DEVELOPMENT APPLICATION ASSESSMENT REPORT

Application Number:	DA2024/0460
---------------------	-------------

Responsible Officer:	Thomas Burns
Land to be developed (Address):	Lot 188 DP 16719, 3 Gondola Road NORTH NARRABEEN NSW 2101 Lot 187 DP 16719, 1 Gondola Road NORTH NARRABEEN NSW 2101
Proposed Development:	Demolition works and construction of shoptop housing
Zoning:	E1 Local Centre
Development Permissible:	Yes
Existing Use Rights:	No
Consent Authority:	Northern Beaches Council
Delegation Level:	NBLPP
Land and Environment Court Action:	No
Applicant:	MacKenzie Architects International

Figure 3 - Building Height Non-Compliance (shaded in yellow)

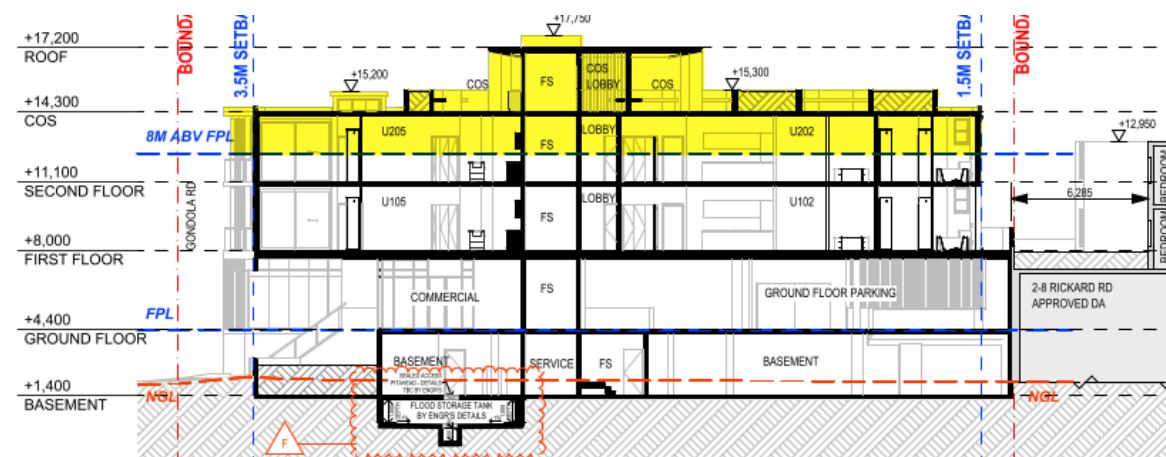
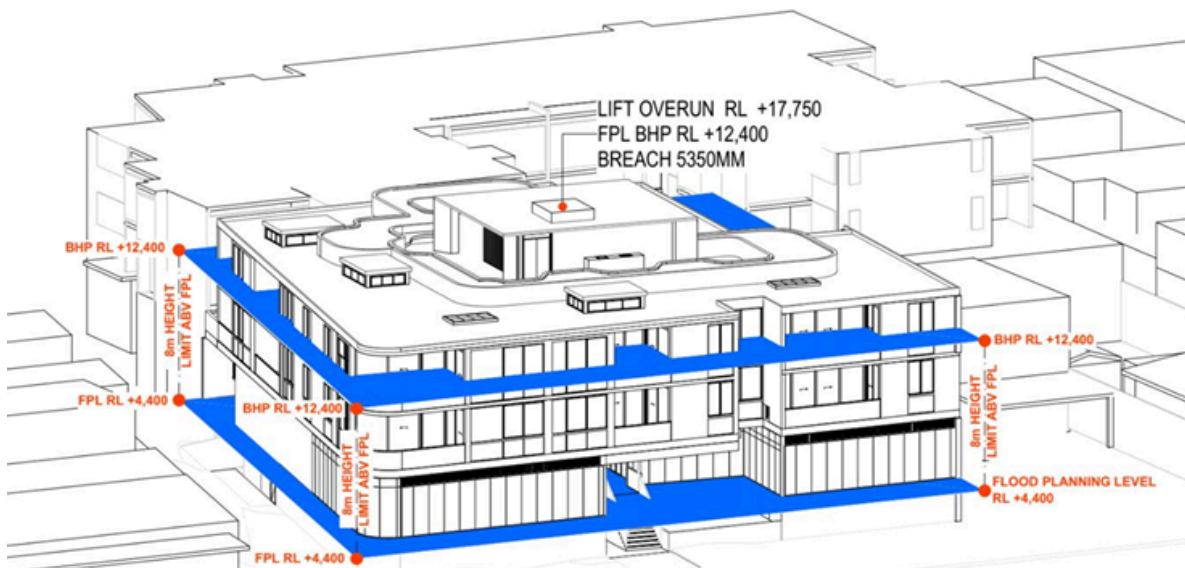
Clause 4.3(2A) of the PLEP states that the maximum height of development on the site must not exceed 8.0m above the FPL, which is established as 12.4m AHD. The proposed development has a maximum height of 17.75m AHD to the lift overrun, the access lobby (level 5) at RL 17.200 and the parapet of level 4 (notated as second floor on Figure 3 below) at RL14.300 all which exceeds the building height standard.

The parapet of the fourth storey element which will be prominent within the public domain has a height of 14.3m AHD, which exceeds the height standard by 1.9m.

Figures 3-4 below depicts the extent of the building that exceeds the building height standard.

It is noted that the roof lobby area and lift overrun on the fifth level (i.e. rooftop access) occupy 9.5% of the entire roof area.

Figure 7 - Demolition plan depicting Tree 6 on the Subject Site and 4 Rickard Road

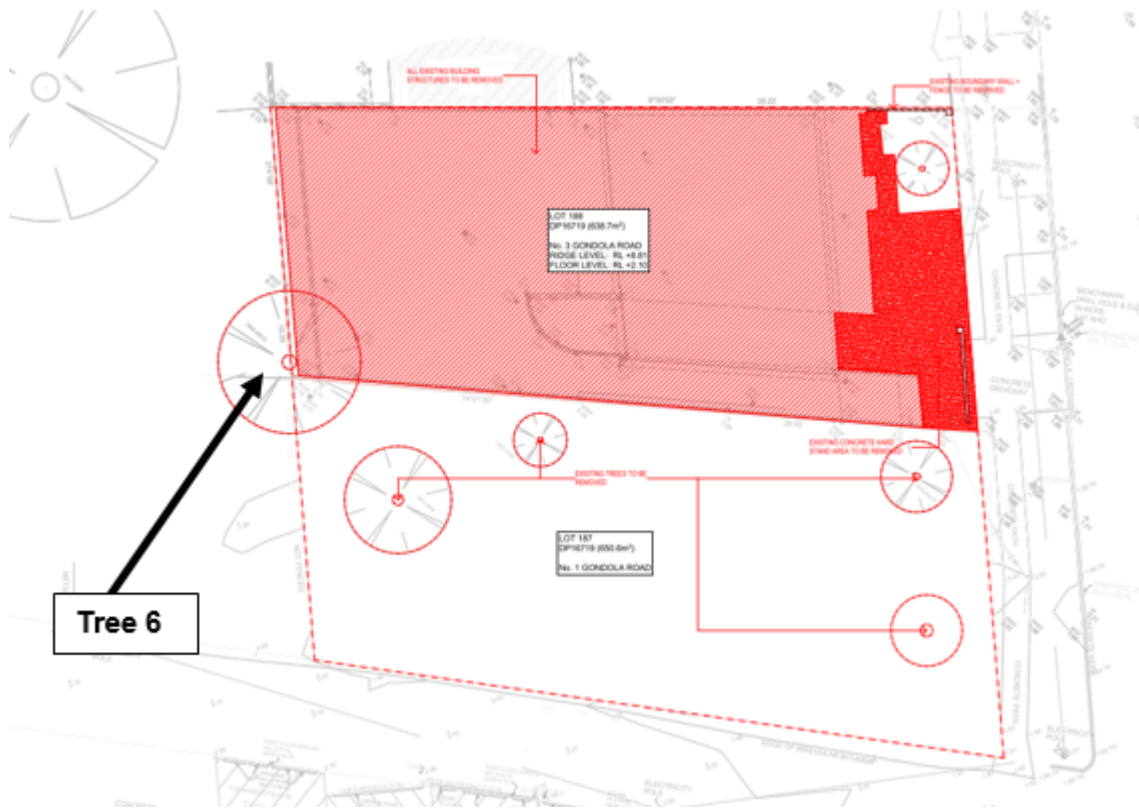
DISCREPANCIES BETWEEN DEMOLITION PLAN AND BOUNDARY IDENTIFICATION SURVEY REGARDING REMOVAL OF TREE 6

The proposed development involves the removal of Tree 6 as identified in the Arboricultural Assessment Report and Tree Protection Specification (AAR) (prepared by Adam Desmarchelier, dated 14 December 2023). The architectural plans identify this tree as being located on both the subject site and the southern adjoining property (4 Rickard Road) (refer to **Figure 7**).

The AAR notes that Tree 6 is a mature *Eriobotrya japonica* (Loquat Tree), which is listed as an exempt species on Council's Exempt tree species list. In this regard, Tree 6 does not require Council approval for removal.

Figure 8 - Tree 6 located entirely within Subject Site (source: applicant's Boundary Identification Survey)

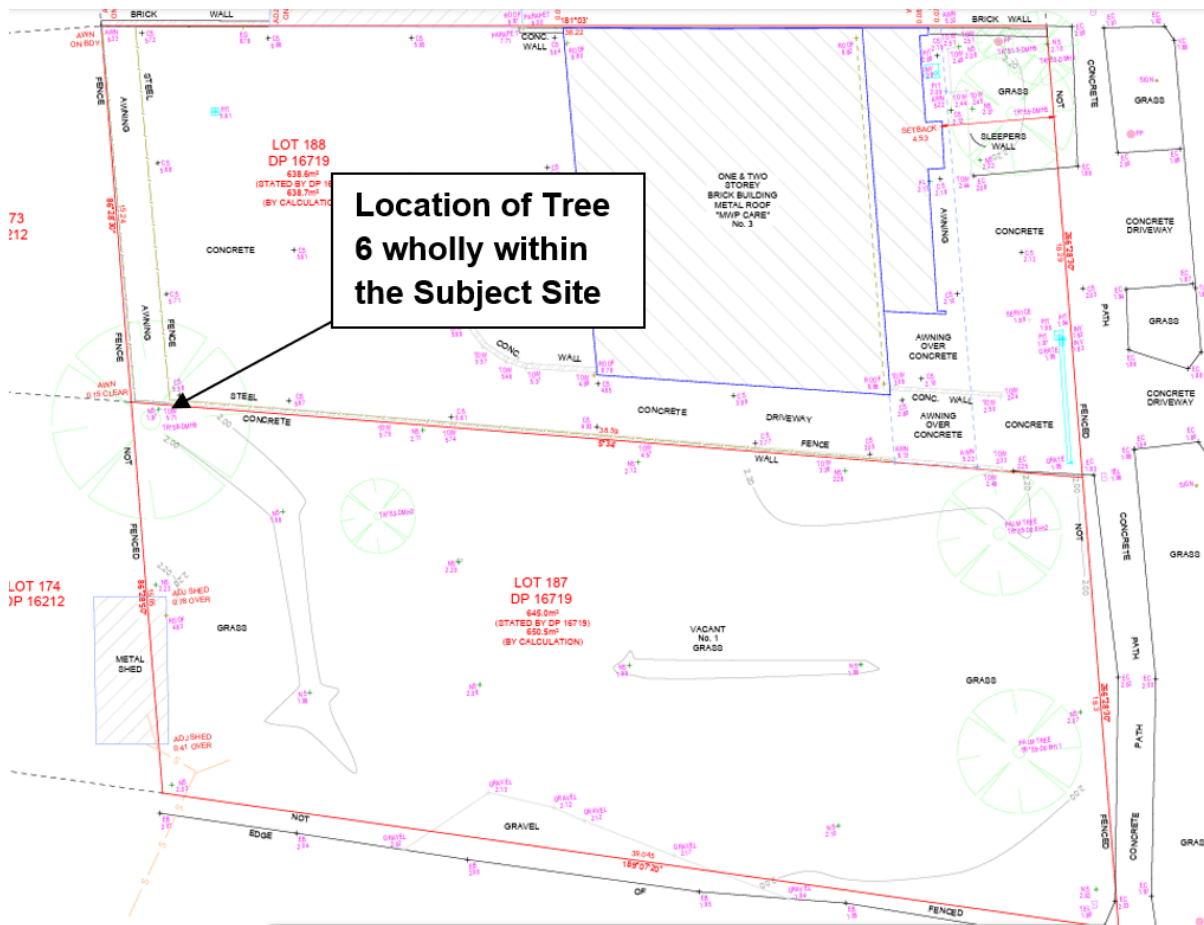
However, the Boundary Identification Survey submitted with this application identifies that this tree is located wholly within the subject site (refer to **Figure 8**).
